URGENT: Fire Extinguisher Valve Co. Ltd (FEV) – safe emptying procedure of cylinders

FXGTEC3300R-D RECALL DUMPY CYLINDER ONLY

INSTRUCTIONS FOR SAFE EMPTYING OF THE CYLINDER

URGENT: Fire Extinguisher Valve Co. Ltd (FEV) – recall of cylinders

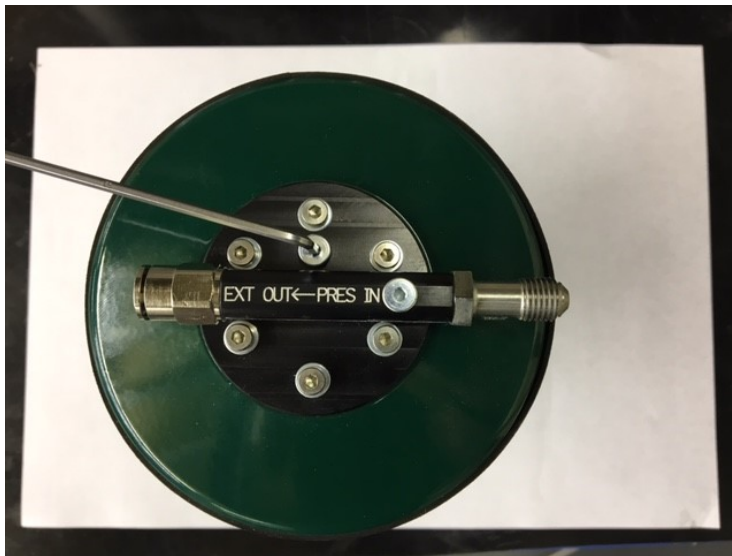
IF TEMPERATURE OF THE CYLINDER IS BELOW 40°C

- Remove the fire extinguisher from car
- Place in a freezer for 90 minutes
- Remove from freezer
- Remove the lower M5 plug from the black flange on the cylinder. See photo below. Make sure this is pointing away from your face.

- Tilt the cylinder upside down to empty the gas from the cylinder.
